Subject: Dow Chemical Company- Response to the Request for Additional Information for the renewed license of the TRIGA research reactor. License No. R-108; Docket No. 50-264

Response to request for additional information

The Dow Chemical Company

May 2011

Figure 1. Upper grid plate

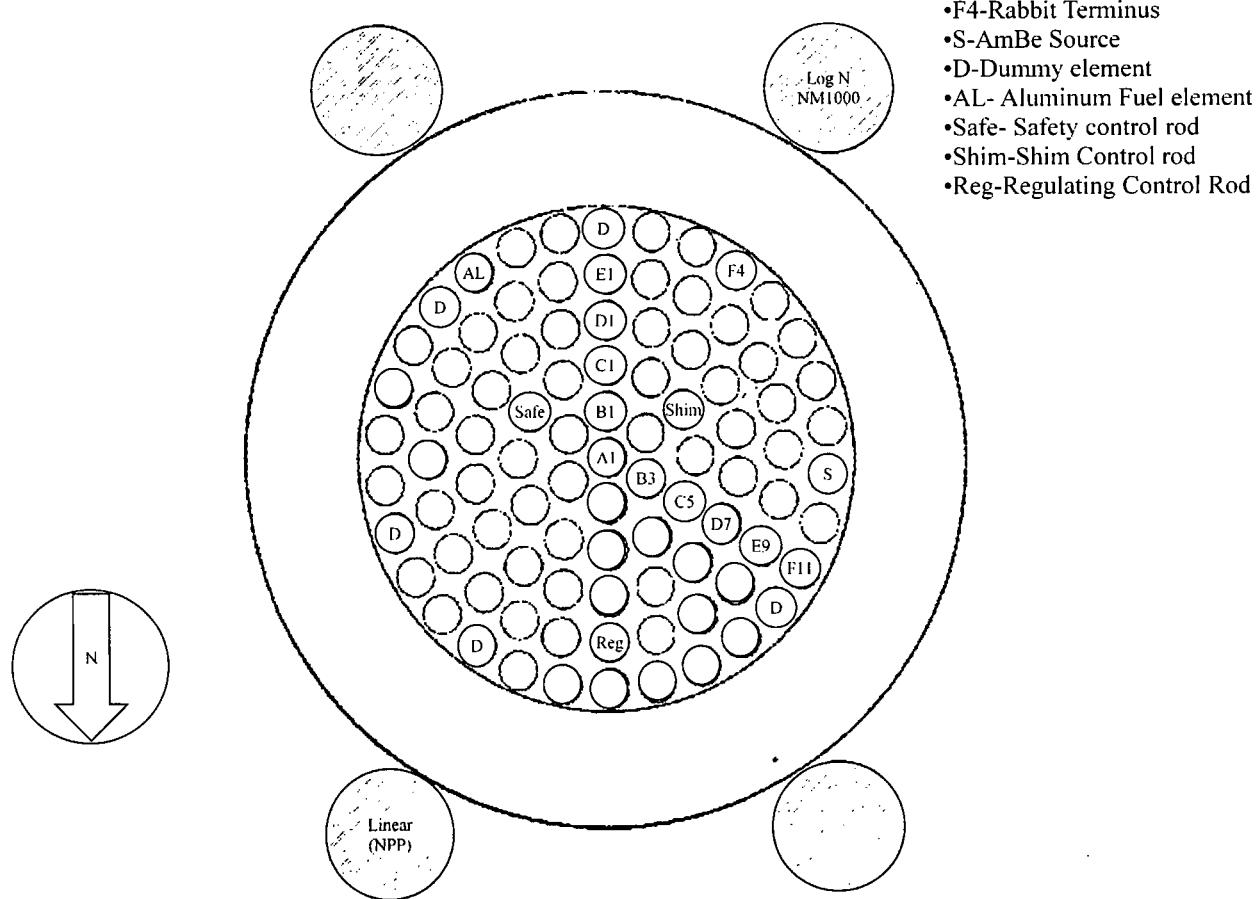
15.2 DTRR SAR, Section A.3, describes the original fuel configuration as having 75 stainless steel (SS)-clad elements and one Aluminum (Al)-clad element. The DTRR SAR does not provide information relating to the DTRR fuel element and control rod layout for the requested power level. Please provide a complete description of the LCC for the requested power level and provide a core diagram showing all components.

15.2 The core configuration is found in Figure 1. The core is loaded with 79 SS fuel elements, 1 Al fuel

element and 5 graphite dummies.

Figure 2. Block Diagram of the console

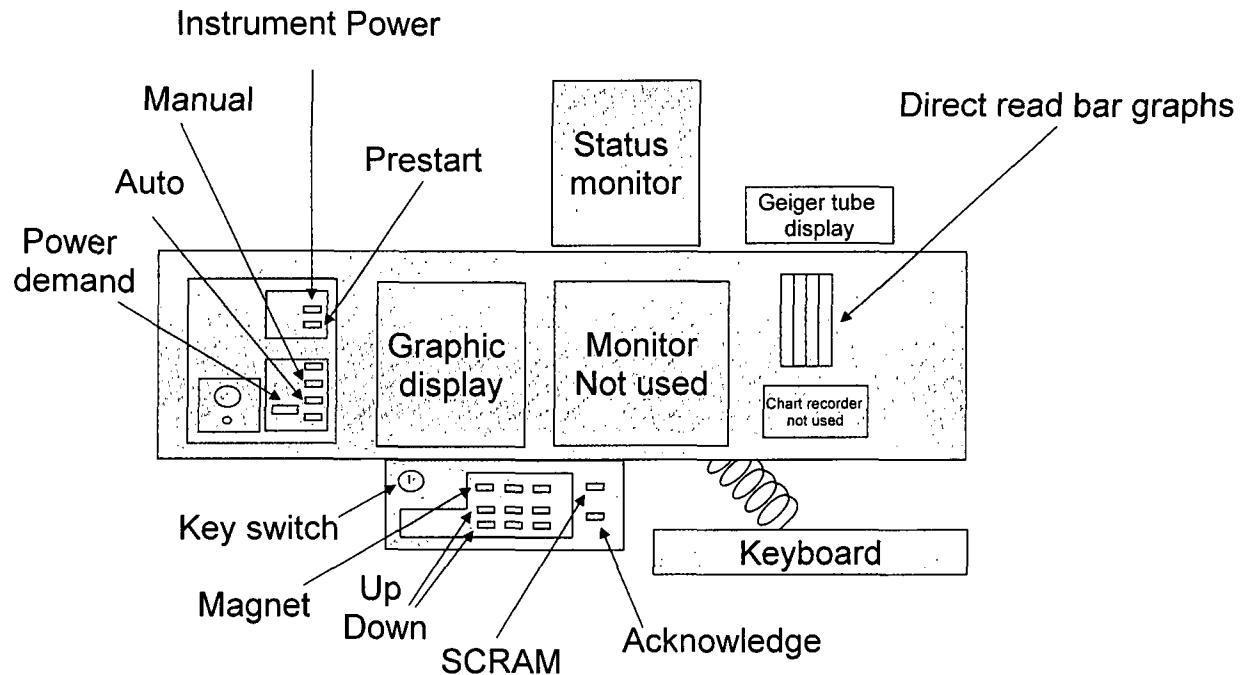
28.3 Please describe the parameter display systems and equipment by which the operator can observe and control the operation of the reactor and important subsystems.

28.3 The power monitoring channels, pool water temperature, and control rod position are displayed at the console at either the graphic display, status monitor or both. The water activity (Geiger tube) is displayed on top of the console. The area radiation monitor reading is displayed on a shelf to the right of the console. Rod drives movement is controlled by buttons located on the console. Figure 2 is a block diagram of the console.
